REPORT AMENDED BY STAFF 5-9-89
CITY PLANNING COMMISSION

P89-130

- A. Negative Declaration
- B. Special Permit to develop a 162,235+ sq. ft. office building with 630 parking spaces in the Heavy Commercial-Review (C-4-R) and Heavy Industrial (M-2) zones
- C. Plan Review for a 162,235+ sq. ft. office building in the C-4-R zone

CALIFORNIA PLAZA
Sacramento, CA

EXHIBIT B

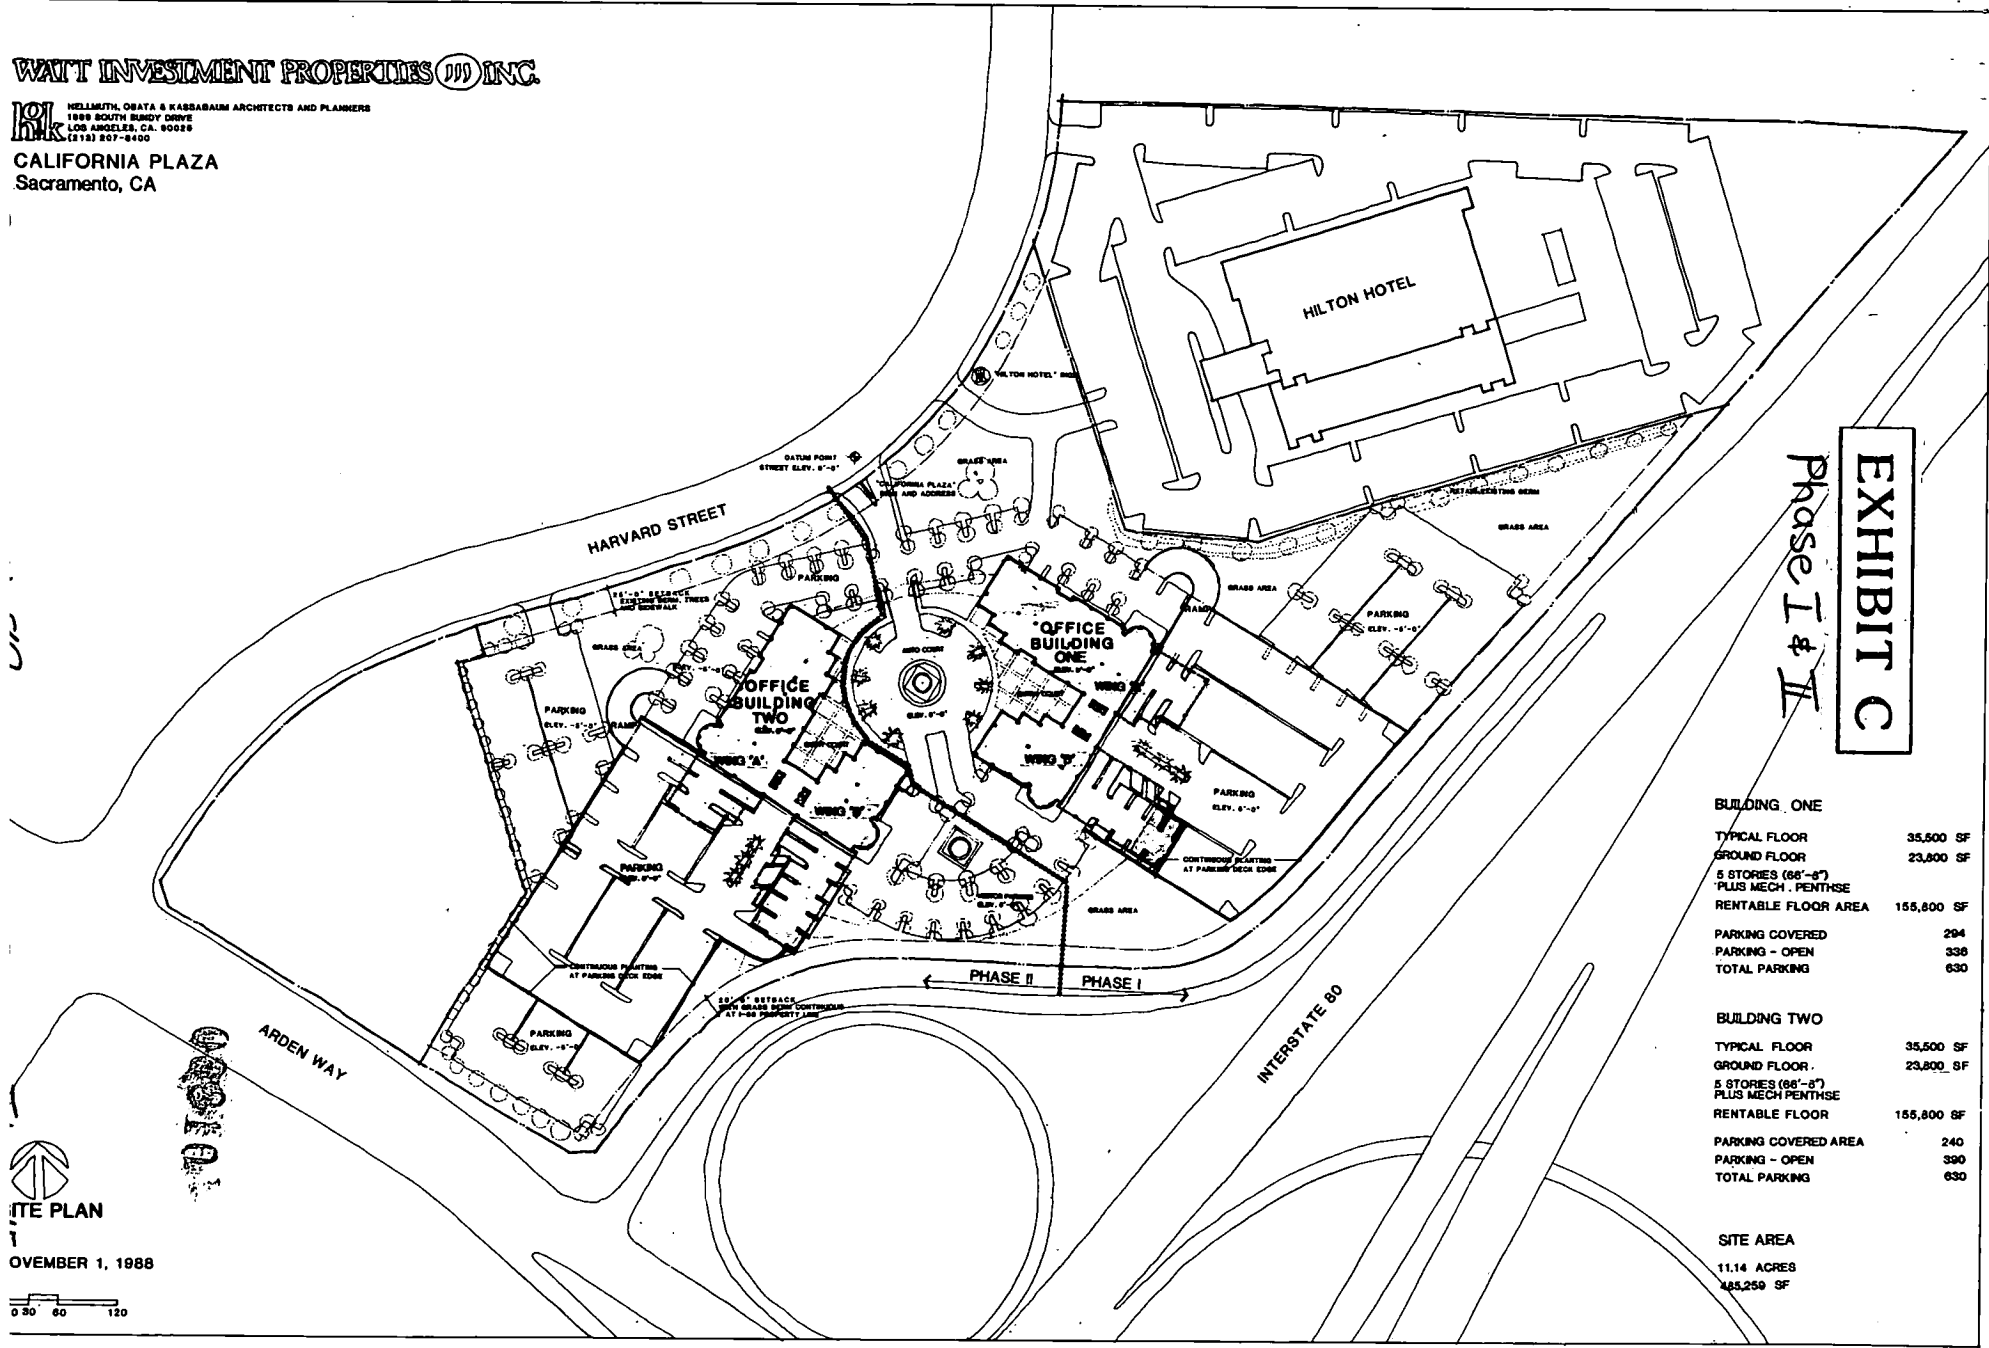
The east side of Harvard Street north of Arden Way to the end of the Hilton Hotel site is presently improved with sidewalk, curb and gutter. A 25 foot wide berm landscaped with trees and grass is located adjacent to the public right-of-way. The applicant intends for this minimum 25 foot setback to remain. Along the east property line adjacent to the freeway right-of-way a minimum 20 foot wide landscaped setback is indicated on the applicant's site plan. This will be compatible with the minimum landscape setback found on the Hilton Hotel site to the north. The applicant should provide a detailed landscape plan for Planning staff review and approval prior to issuance of building permits. Staff is especially interested in: the addition of landscaping on top of the parking deck; the proposed planting material at the parking deck edge and at the edge of the visitor parking; landscaping details at the auto court and entry court; and the location and type of existing and proposed trees and shrubs. The applicant will be required to meet the City's shading ordinance requirements.

The site plan and floor plans for the building indicate an entry court into the building. The applicant has indicated that proposed hardscape materials include smooth concrete and sandblasted concrete. Staff recommends that a brick paving material be included as part of the hardscape treatment. Planning staff also recommends that the applicant explore carrying the decorative treatment used at the entry court onto the top parking deck level.

A trash storage room has been indicated on the submitted floor plan. If any other trash areas are proposed the revised site plan should indicate these trash

The site plan indicates 630 parking spaces for the proposed office building. This number of spaces exceeds the minimum requirement of one space per 400 gross square feet (406 spaces). Planning staff recommends that, if it is necessary to reduce the number of parking spaces for the project, the applicant maintain a minimum parking ratio of one space per 300 gross square feet (541 spaces) which is also the parking requirement of the adjacent Capitol West Office Park PUD. Bicycle parking per Zoning Ordinance is also required.

1. All driveways shall be parallel to the street. Entry driveway divider shall be set in 20 feet from property line.
2. Provide plans showing parking ramp elevations and stall specifications.
3. Southern driveway shown for Phase II should be 30 feet in width and align with parking aisle.

- 1. A landscape, shading and irrigation plan shall be submitted and subject to Planning Director review and approval prior to issuance of building permits. The landscape plan shall detail the following:
 - a. minimum 25 foot landscape setback along Harvard Street as indicated on submitted site plan;
 - b. minimum 20 foot landscape setback adjacent to the freeway right-of-way as indicated on the submitted site plan;
 - c. addition of landscaping on top of the parking structure;
 - d. proposed planting material at the parking deck edge and at the edge of the visitor parking;
 - e. landscaping details at the auto court and entry court; and

- f. the location and type of existing and proposed trees and shrubs.
2. Final plans and elevations for the 162,235+ square foot office building, parking structure and entry court area shall be submitted for Planning Director review and approval prior to issuance of building permits. Revised plans shall indicate a decorative hardscape treatment including the use of brick, a decorative motif incorporated into the precast concrete panels of the building, and a screening treatment between the first and second levels of the parking structure where appropriate.

EXHIBIT C
 Phase I & II

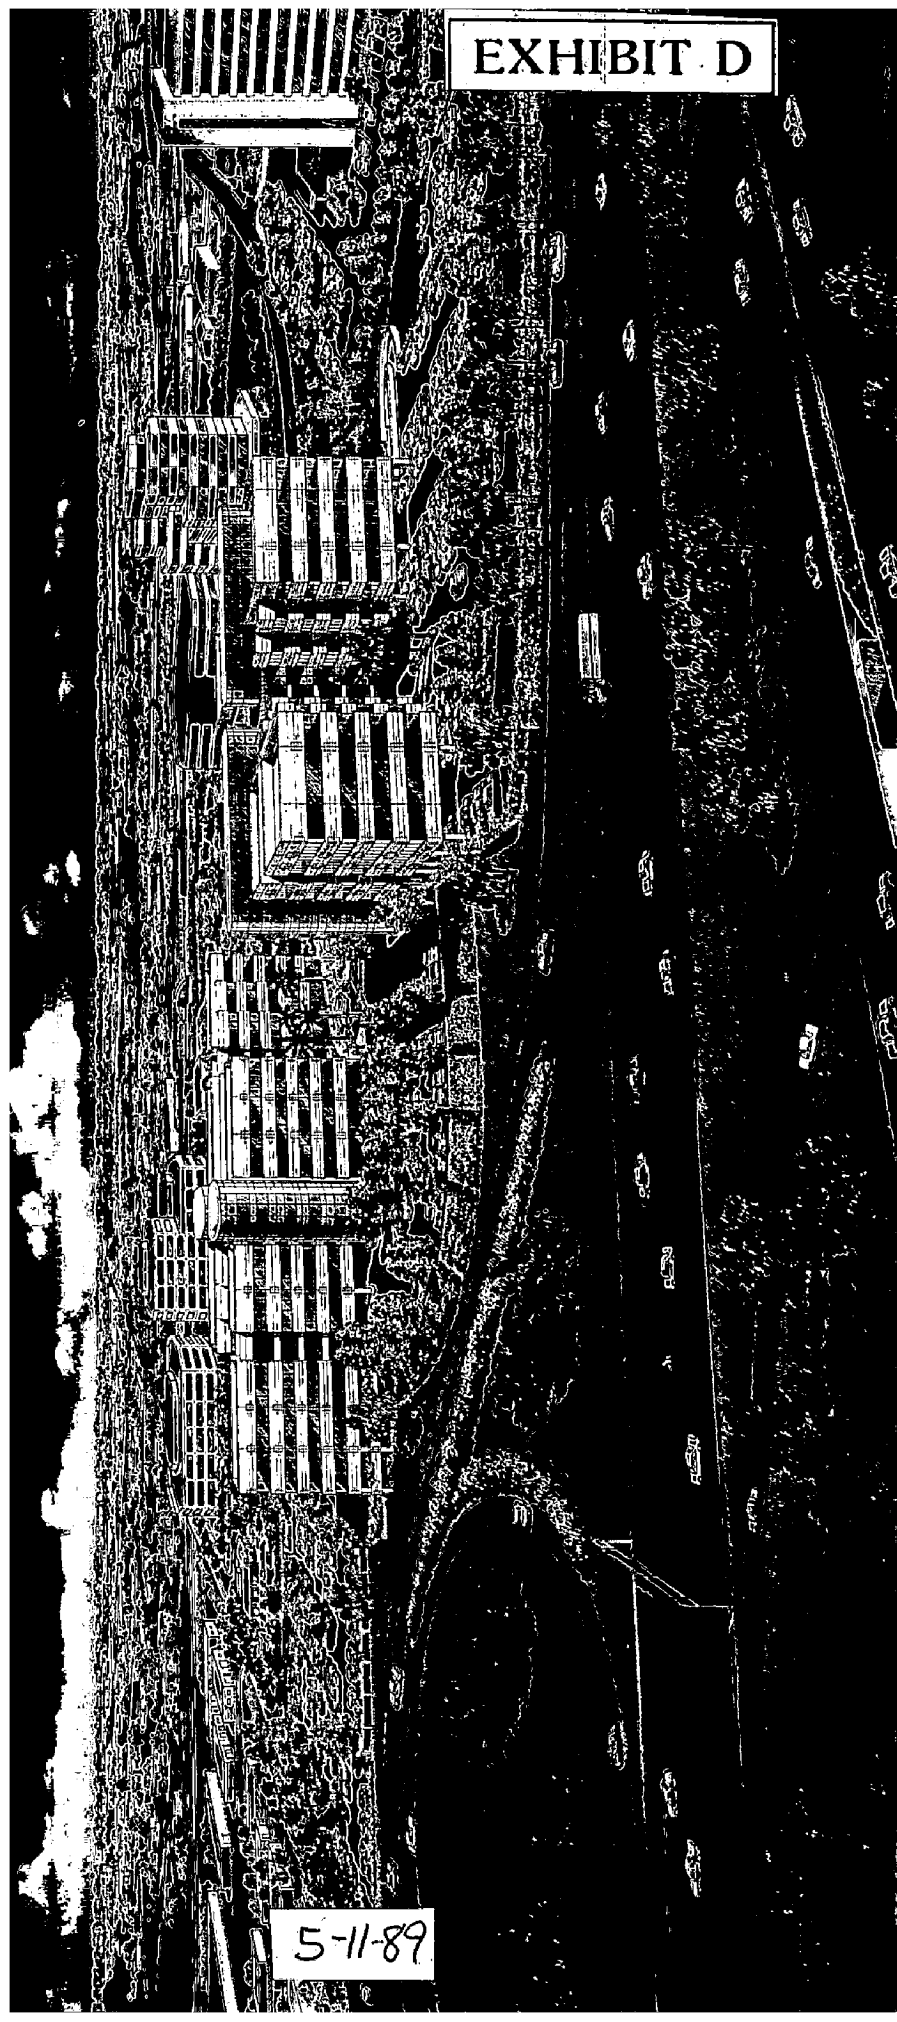
The applicant proposes to construct a 162,235+ square foot, 72+ foot high office building on the northern 6.13+ acres of the 11.14+ acre vacant parcel (Exhibits B-G). The project would include 630 parking spaces, a portion which would be below grade. As the proposed office is located in the C-4 and M-2 zones a special permit to develop a project which is 100% office use is required. A development plan review for a project in the C-4-R zone is also required. The proposed office building would be Phase I of a two phase office project (Exhibit C), however the applicant is requesting approval of Phase I only at this time.

EXHIBIT E

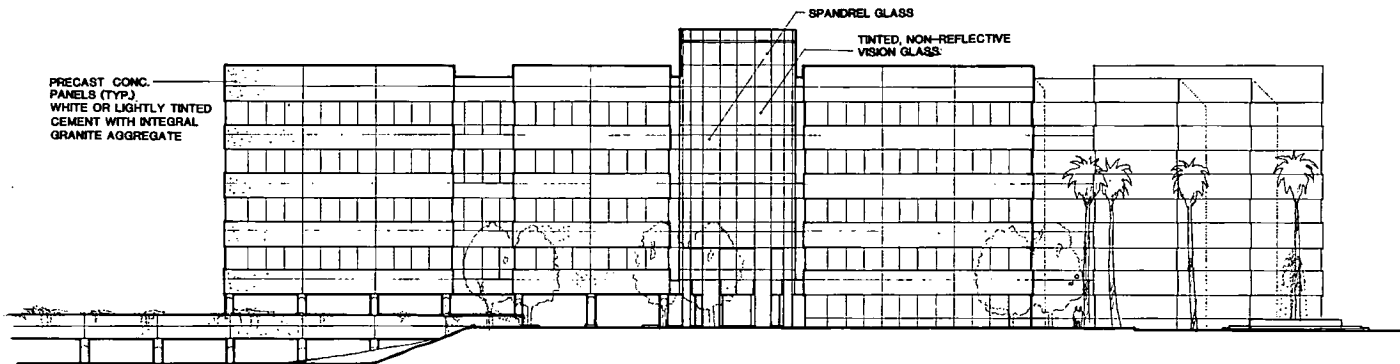
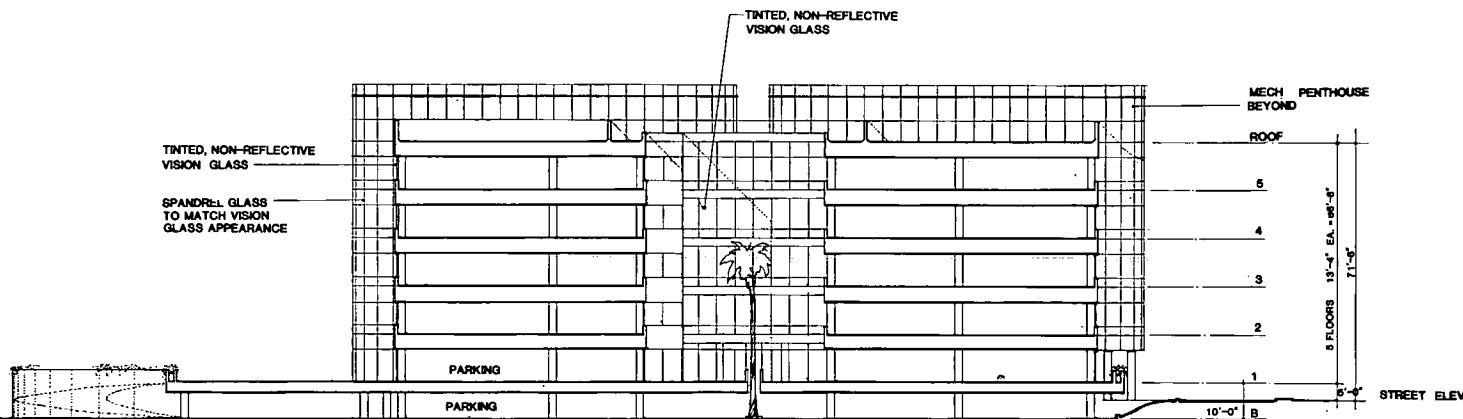
The proposed 162,235+ square foot office building consists of two, five-story wings connected by a five-story glass atrium. The mechanical equipment on top of the building will be shielded by a spandrel glass screen surrounding the top of the roof. Proposed height is 71'8" to the top of the roof and 87'8" to the

top of the building (mechanical equipment screen) measured from the Harvard Street grade. A level of parking will be constructed five feet below grade. Proposed building materials are pre-cast concrete panels with granite, and tinted glass. Proposed building colors range from white pre-cast concrete, grey tinted glass and blue metal mullions to a sand precast concrete, green tinted glass and teal mullions. A lighter tinted glass would be used in the atrium area with a darker tint on the building wings.

Planning staff finds the proposed building design to be interesting and compatible with the adjacent office buildings and Hilton Hotel. The building height is within the limits of the C-4 and M-2 zones (Maximum height 75 feet to plate line, 90 feet to top of mechanical equipment penthouse) and is similar to the surrounding buildings. The proposed building should have a decorative motif incorporated into the pre-cast concrete panels, such as the use of reveal lines. Planning staff prefers the sand pre-cast concrete and green tinted glass material samples presented by the applicant rather than the white/grey combination as the white building appears too stark. Planning staff recommends that the final architectural detailing for the project be reviewed and approved at staff level prior to issuance of building permits.
